Global Forum for Road Traffic Safety

Convention on Road Signs and Signals (1968)

Proposal for amendments to Annex 1 and 3

Submitted by the Chair of the Group of Experts on Road Signs and Signals and secretariat

DANGEROUS DESCENT

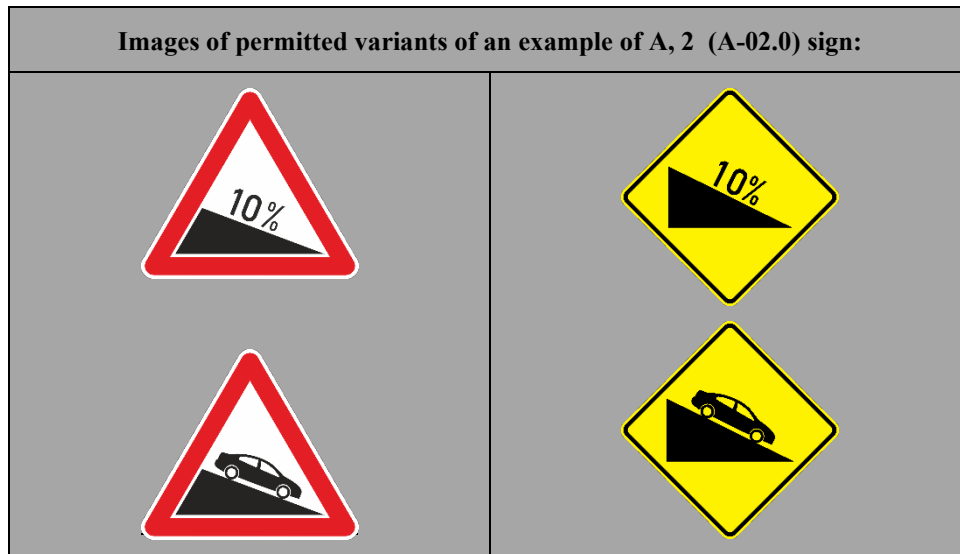
(a) To give warning of a steep descent symbol A, 2a shall be used with the sign of model Aa, or symbol A, 2b with the sign of model Ab.

(b) The left hand part of symbol A, 2a shall occupy the left hand corner of the sign panel and its base shall extend over the whole width of the panel. The figure in symbols A, 2a and A, 2b shows the gradient as a percentage; it may be replaced by a ratio (1:10). It shall, however, be open to Contracting Parties taking into account as far as possible the provisions of Article 5, paragraph 2 (b) of this Convention, to use, instead of symbol A, 2a or A, 2b, symbol A, 2c if they have adopted the sign of model Aa and symbol A, 2d if they have adopted the sign of model Ab.

A, 2 (A-02.0) gives warning of a dangerous descent. The symbol of either a car or a percentage or both, may be used. An arrow in the ground colour of the sign may be embedded into the black triangular part of the symbol when the percentage symbol is used.

STEEP ASCENT

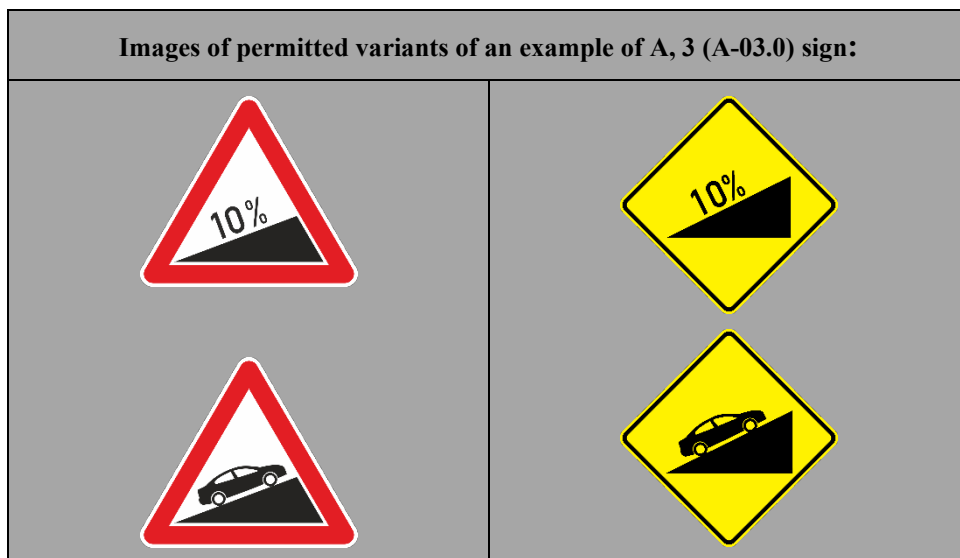
(a) To give warning of a steep ascent, symbol A, 3a shall be used with the sign of model Aa, or symbol A, 3b with the sign of model Ab.

(b) The right hand part of symbol A, 3a shall occupy the right hand corner of the sign panel and its base shall extend over the whole width of the panel. The figure in symbols A, 3a and A, 3b shows the gradient as a percentage; it may be replaced by a ratio (1:10). It shall, however, be open to Contracting Parties which have chosen symbol A, 2c as the symbol for a dangerous descent to use symbol A, 3c instead of A, 3a, and to Contracting Parties which have chosen symbol A, 2d to use symbol A, 3d instead of A, 3b.

A, 3 (A-03.0) gives warning of a steep ascent. The symbol of either a car or a percentage or both, may be used. An arrow in the ground colour of the sign may be embedded into the black triangular part of the symbol when the percentage symbol is used.

OPENING BRIDGE

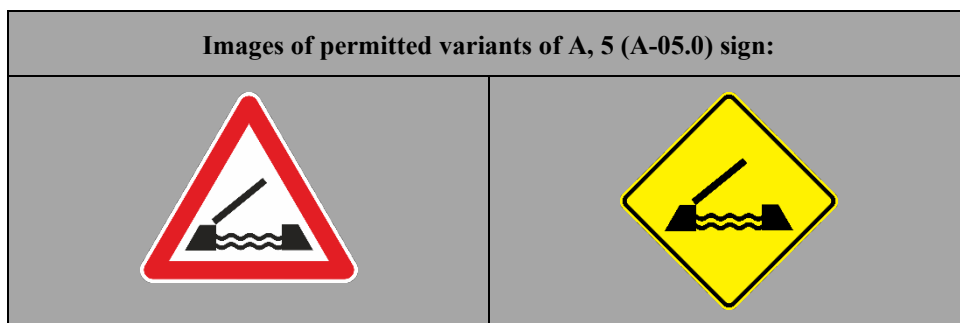
~~(a) Warning of a opening bridge shall be given by the symbol A, 5.~~

~~(b) A rectangular panel of model **The sign** A, 29a (A-26.1) described in paragraph 29 below may be placed below this sign the danger warning sign bearing symbol A, 5 provided that panels of model signs A, 29b and A, 29c (A-26.2 and A-26.3) described in that paragraph~~

A, 5 (A-05.0) gives warning of an opening bridge.

are set up at approximately one third and two thirds of the distance between ~~the~~ **the sign A29a bearing symbol A, 5** and the opening bridge.

LOOSE GRAVEL

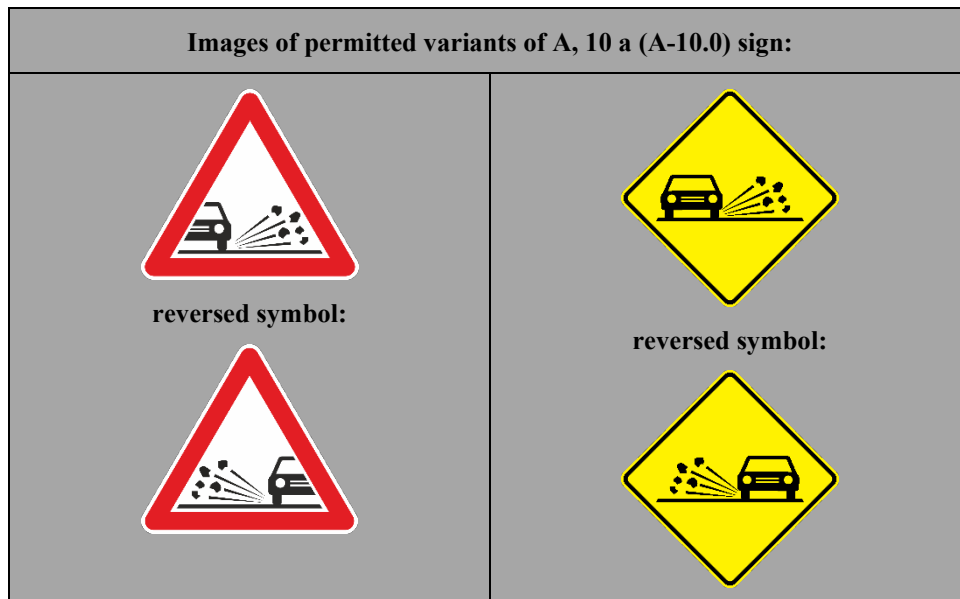
~~Warning of a section of road on which gravel may be thrown up shall be given by symbol A, 10a used with the sign of model Aa or by symbol A, 10b with the sign of model Ab.~~

A, 10 a (A-10.0) gives warning of a section of road on which gravel may be thrown up. The symbol on this sign may be reversed.

FALLING ROCKS

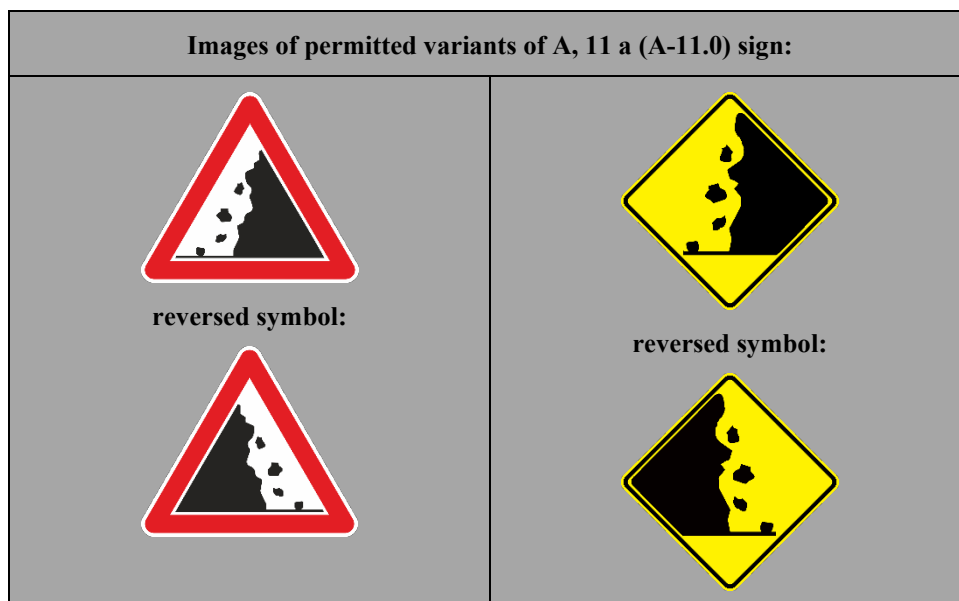
~~(a) Warning of a section of road on which there is danger from falling rocks and the consequent presence of rocks on the carriageway shall be given by symbol A, 11a used with the sign of model Aa or by symbol A, 11b with the sign of model Ab.~~

~~(b) The right hand part of the symbol shall occupy the right hand corner of the sign panel in both cases.~~

~~(c) The symbol may be reversed.~~

A, 11 a (A-11.0) gives warning of a section of road on which there is danger from falling rocks and the consequent presence of rocks on the carriageway. The symbol on this sign may be reversed.

PEDESTRIAN CROSSING

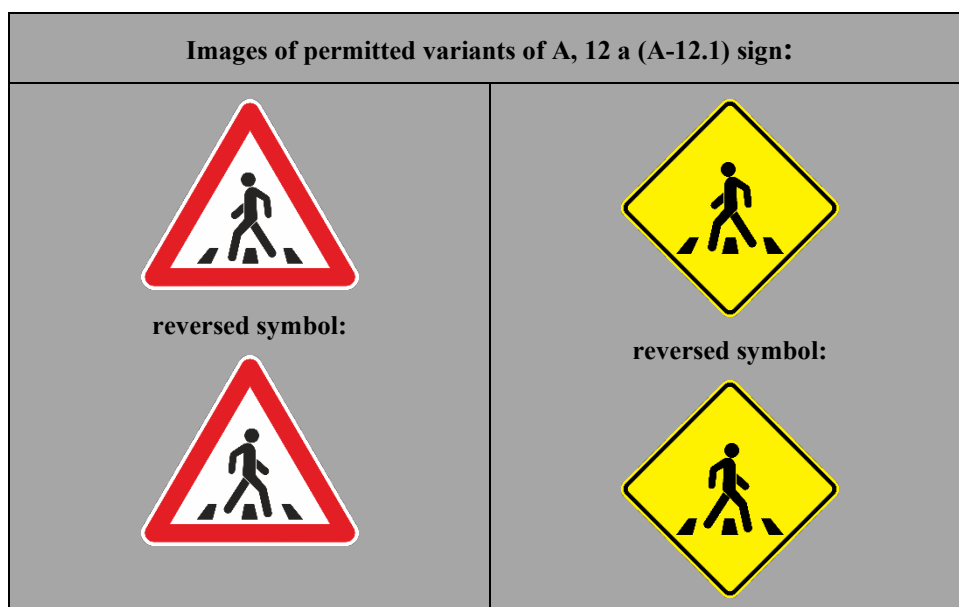
~~(a) Warning of a pedestrian crossing indicated either by road markings, or by signs E, 12 shall be given by symbol A, 12 of which there are two models: A, 12a and A, 12b.~~

~~(b) The symbol may be reversed.~~

A, 12 a (A-12.1) gives warning of a pedestrian crossing indicated either by road markings of broad stripes parallel to the axis of the carriageway, or by sign E, 12 (E-10.0). The symbol on this sign may be reversed.

CHILDREN

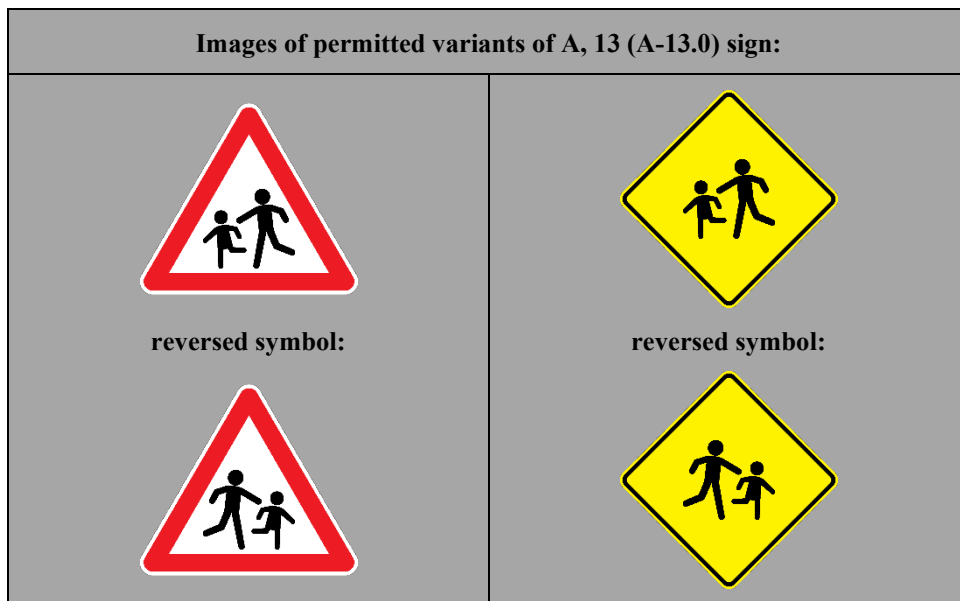
~~(a) Warning of a section of road frequented by children, such as the exit from a school or playground shall be given by symbol A, 13.~~

~~(b) The symbol may be reversed.~~

A, 13 (A-13.0) gives warning of a section of road frequented by children, such as within the proximity of a school or playground. The symbol on this sign may be reversed.

TRAFFIC LIGHT SIGNALS

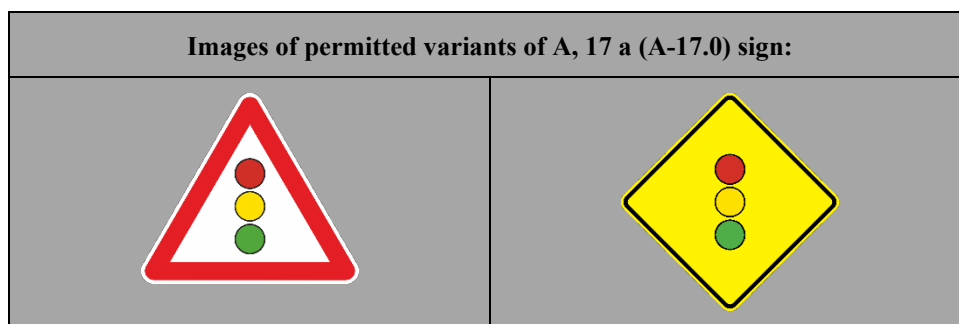
~~(a) If it is considered essential to give warning of a section of road on which traffic is regulated by three colour light signals, because road users would not expect such a section, symbol A, 17 shall be used. There are three models of symbol A, 17: A, 17a ; A, 17b ; and A, 17c , which correspond to the arrangements of lights in the three colour system described in Article 23, paragraphs 4 to 6 of this Convention.~~

~~(b) This symbol shall be in the three colours of the lights of which it gives warning.~~

A, 17 (A-17.0) gives warning of a section of road on which traffic is regulated by three-colour traffic light signals. The symbol shall be in the three colours of the traffic lights of which it gives warning. These three colours shall be surrounded by a dark colour narrow strip.

This sign shall only be used on road sections on which road users would not expect traffic light signals.

This sign may be set up to supplement or replace the signs described in paragraphs 18 to 21 if traffic at the intersection is regulated by a traffic light signal.

INTERSECTION WITH A GIVE WAY ROAD

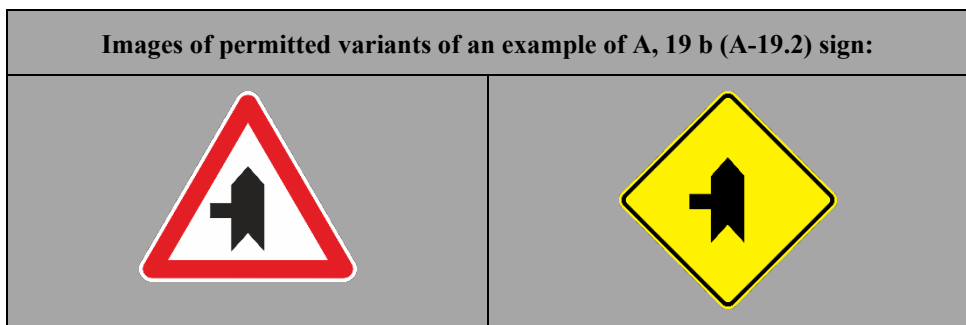
~~(b) Symbol A, 19a may be replaced by symbols which show the nature of the intersection more clearly, such as A, 19b and A, 19c.~~

~~(c) These symbols~~ **The signs A, 19 a and A, 19 b (A-19.1 and A-19.2) may be used on a road only if sign B, 1 or sign B, 2 (B-01.0 or sign B-02.0) is placed on the road or roads with which the intersection of which warning is given, or if these roads are such (for example, paths or earth-tracks) that, under domestic legislation, drivers using them are required to give way at the intersection even in the absence of such signs. The use of these symbols on roads on which sign B, 3 (B-03.0) is set up shall be confined to certain exceptional cases.**

A, 19 b (A-19.2) gives warning of an intersection with a road the users of which must give way and shows an example of a specific nature of the intersection.

TRAFFIC CONGESTION

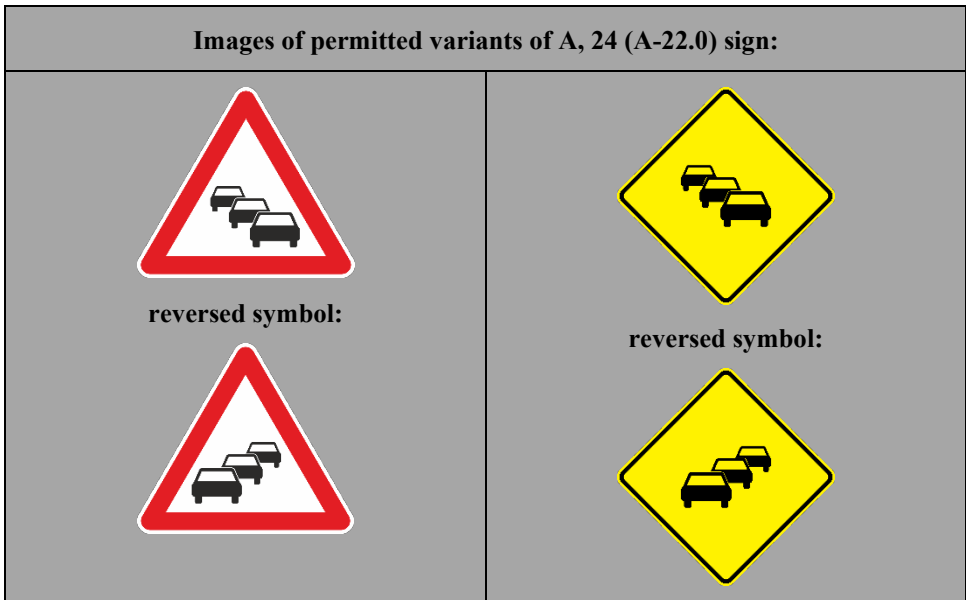
~~(a) Warning that there may be traffic congestion on the section of road ahead shall be given by symbol A, 24.~~

~~(b) The symbol may be reversed.~~

A, 24 (A-22.0) gives warning that there may be traffic congestion on the section of road ahead. The symbol on this sign may be reversed for traffic keeping to the left.
